UNITED STATES PATENT AND TRADEMARK OFFICE

APPLICATION NO.	FILING DATE	FIRST NAMED INVENTOR	ATTORNEY DOCKET NO.	CONFIRMATION NO.
10/602,210	06/24/2003	David B. Griep	066042-9326-00	2237

Office Action Summary

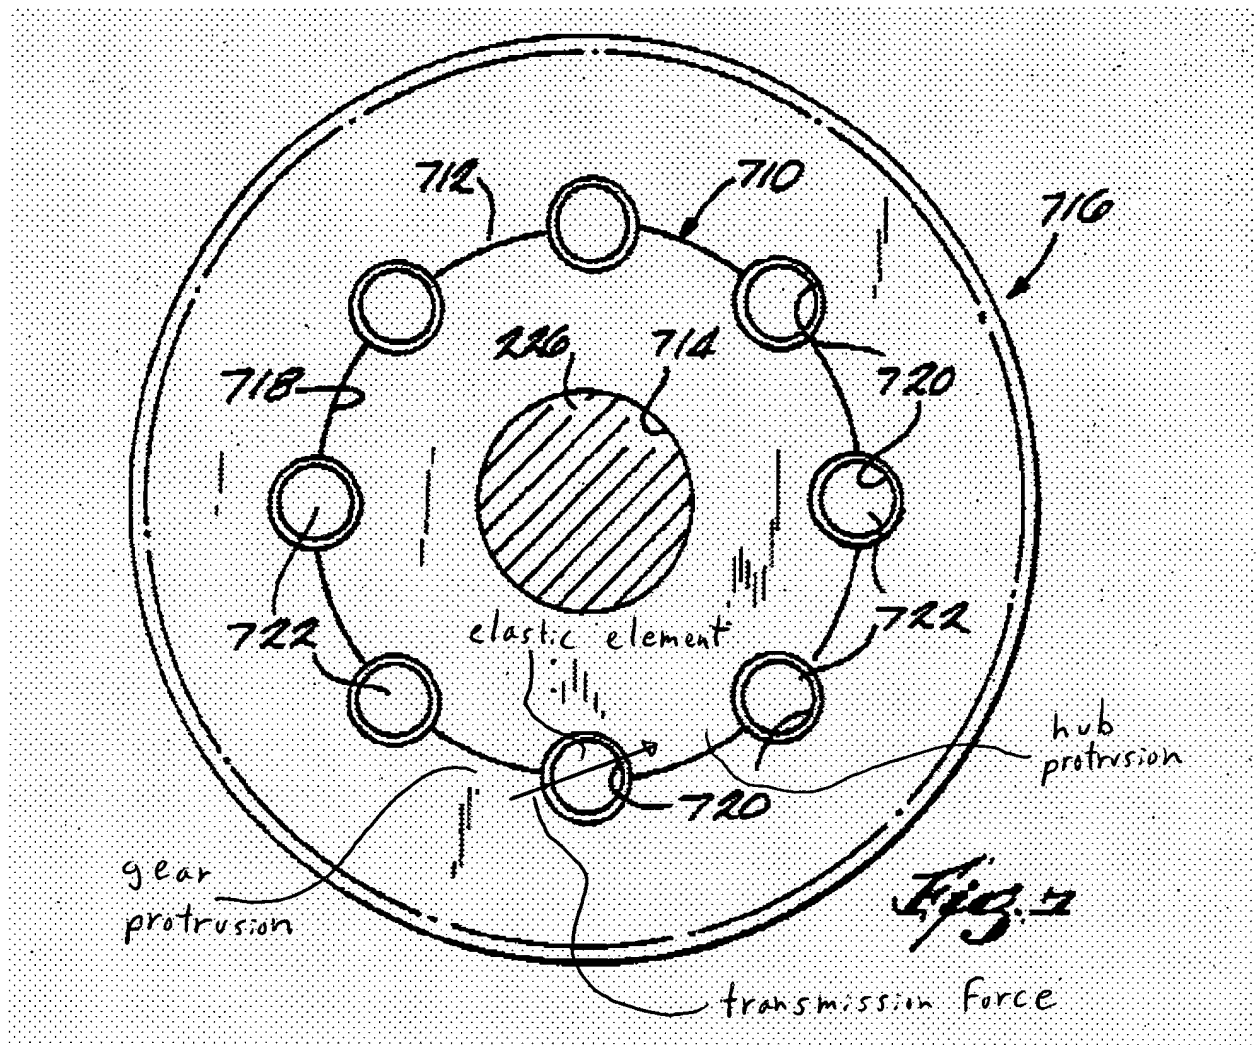
Applicant argues that Palm does not teach "*an elastic member positioned between the gear protrusion and the hub protrusion*". This is incorrect as seen in Palm's figure 7. The elastic element (722) is between the gear protrusion and the hub protrusion along a line of force transmission, as seen herebelow.
